PLANNING COMMISSION STAFF REPORT

**Granite Furniture Block – Red Mountain Retail Group
Building and Site Design Review
PLNPCM2008-00211
2100 South & McClelland Street
January 28, 2009**

B1 - PARKING MAIN LEVEL

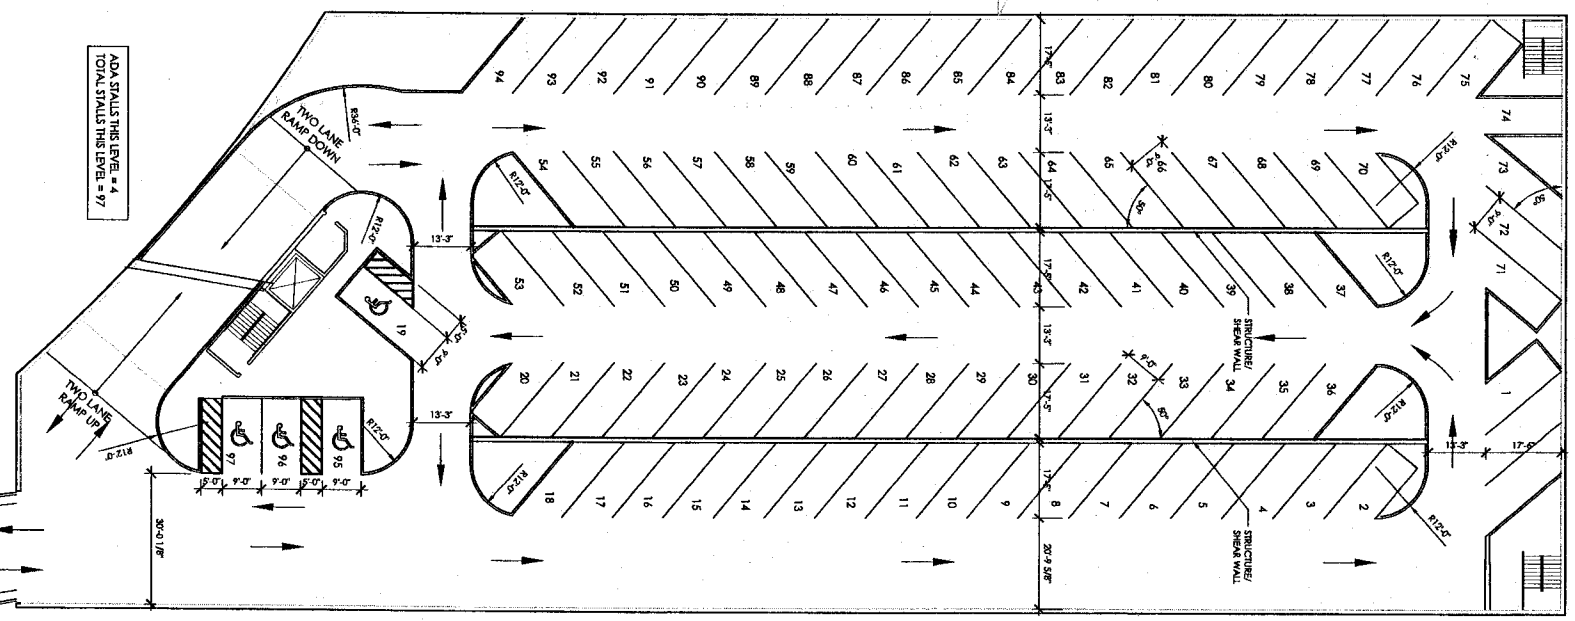
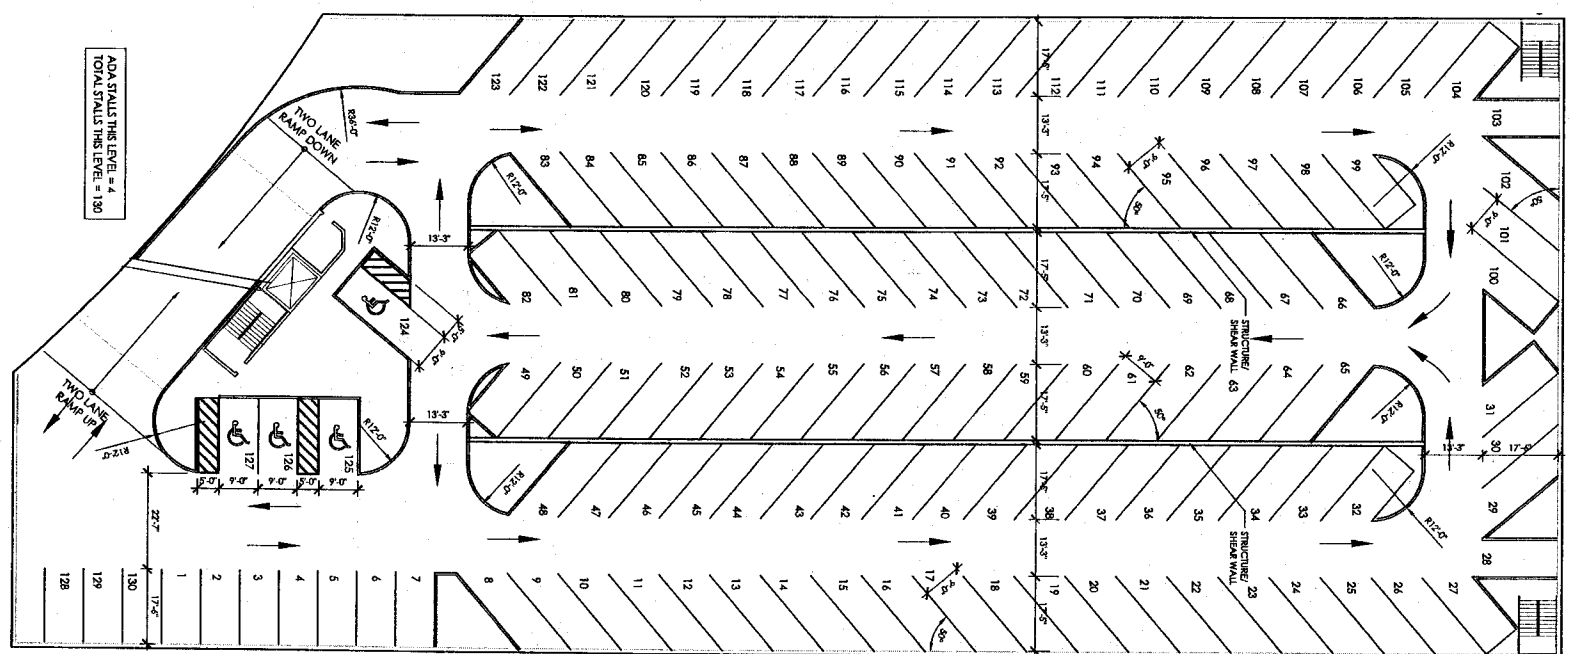
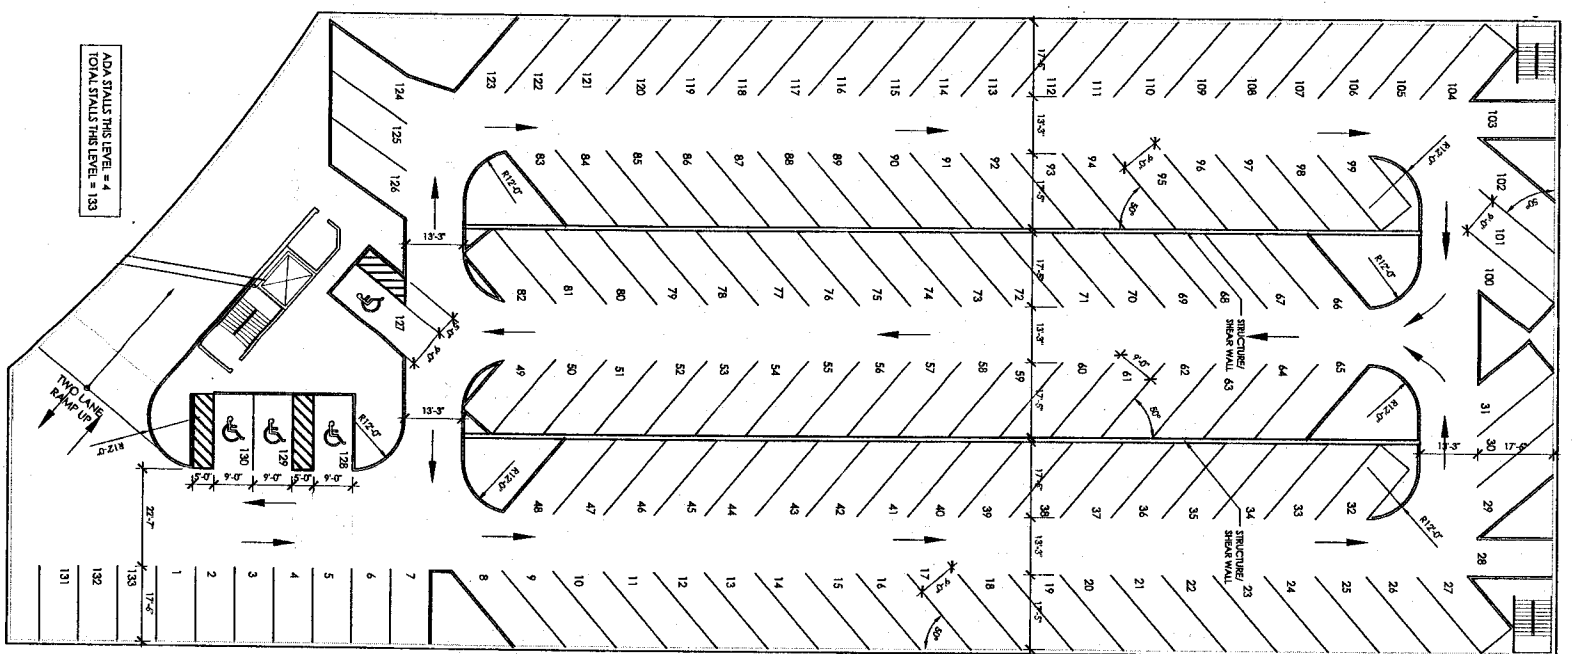
Please clarify the ramp shown on building B1 main level to and upper level?.
